Errata for *What's a Microcontroller? v2.2* (#28123)

Figure 5-3

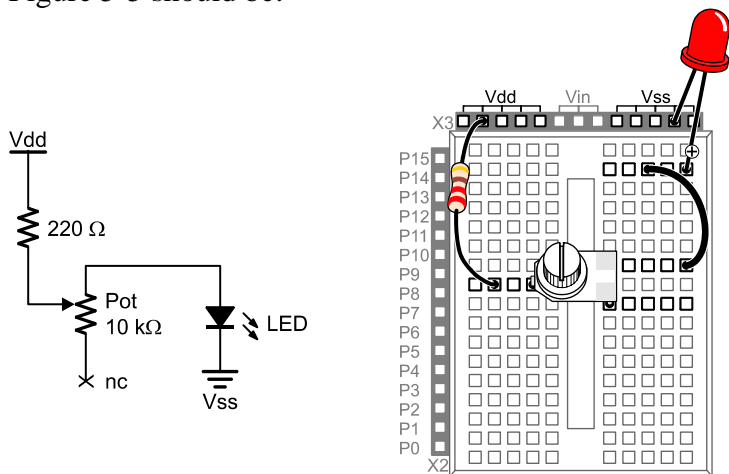
Page 140: In *What's a Microcontroller Parts Kits* purchased after January 10, 2007, the potentiometer may look different from the one shown in the text. The two styles are functionally the same, with the same terminals. Here are alternative drawings:
